Groundwater Transfer Review Summary Form

Transfer/PA # T- 14913

Application: T-14913

Applicant Name: Fessler Nursery / Marvin Fessler

Well Lithology**Hydrograph (annual Spring high) for APOAs**

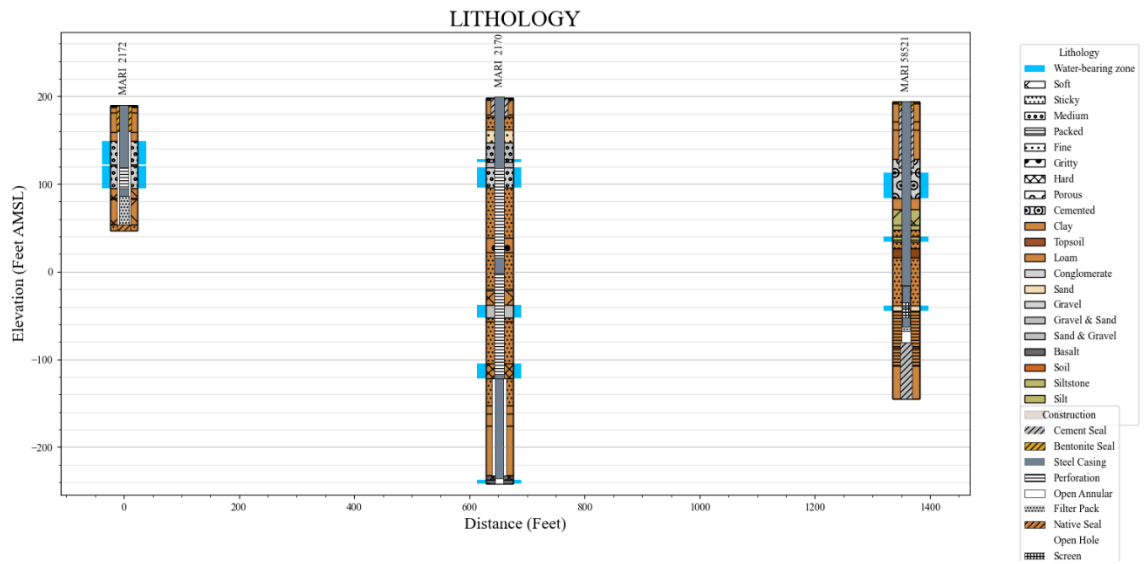
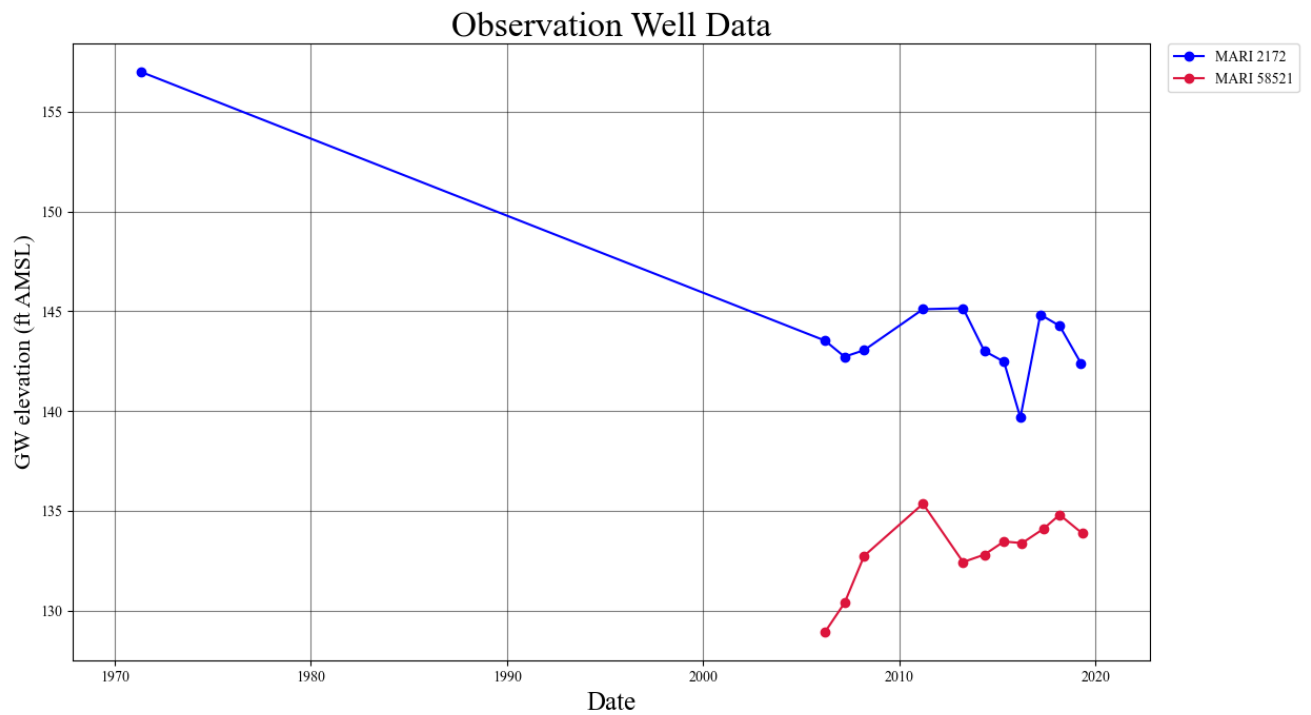
3. Will the proposed POA develop the same aquifer (source) as the existing authorized POA?
☒ Yes ☐ No Comments: The authorized POA is completed in multiple water-bearing zones within the Willamette Aquifer, and is open to the Middle Sedimentary Unit and Lower Sedimentary Unit (Gannett and Caldwell, 1998; Conlon et al., 2005). Based on unit thicknesses modified from Gannett and Caldwell, 1998, the proposed POA Well 1 (MARI 2172) develops the Middle Sedimentary Unit, and the proposed POA Well 6 (MARI 58521) develops the Lower Sedimentary Unit. Therefore, the APOAs are completed in the same aquifer as the authorized POA, Well 3 (MARI 2172).

4. a) Is the existing authorized POA subject to a water level decline condition?
☐ Yes ☒ No Comments: Only the proposed APOAs are subject to a water level decline condition under Permit G-15676.

Map

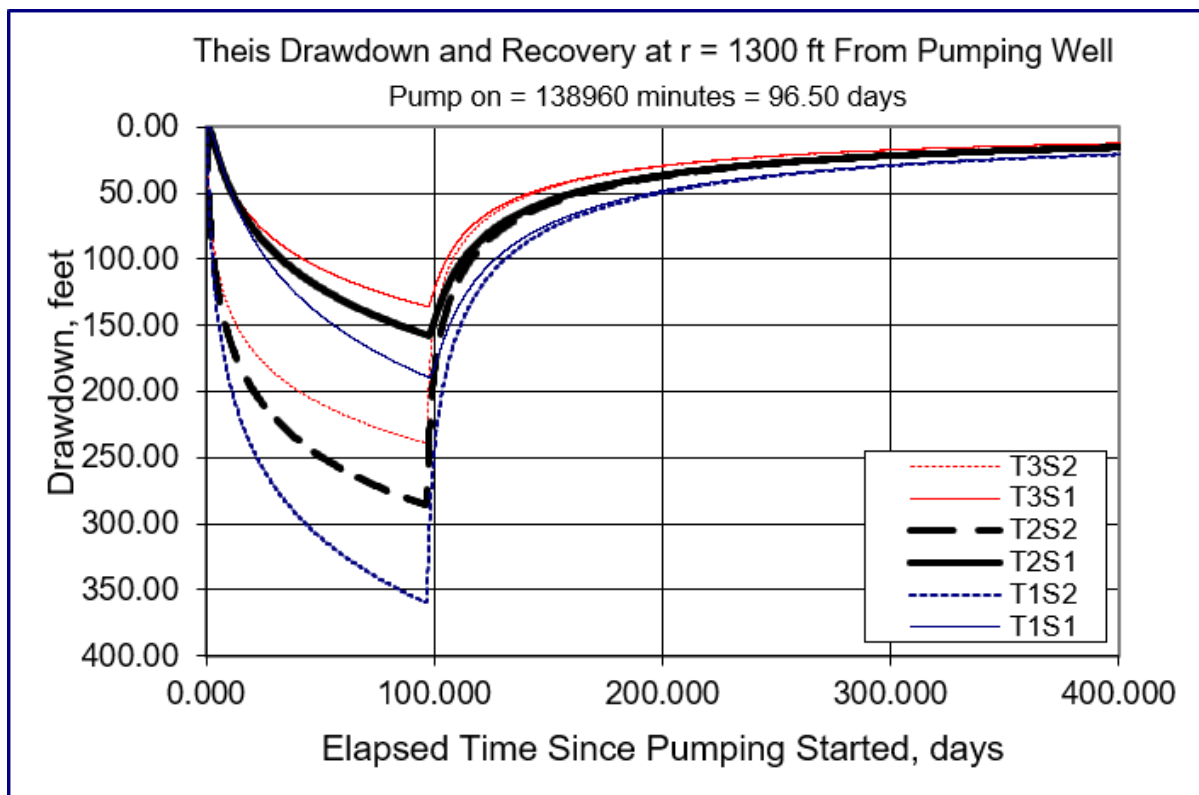
☒ Yes ☐ No Comments: The nearest groundwater right not owned by the applicant is MARI 2023 (Certificate 36305). Well 6 (MARI 58521) is 700 feet closer to MARI 2023 than the authorized POA. Well 1 (MARI 2172) and the authorized POA are the same distance from MARI 2023.
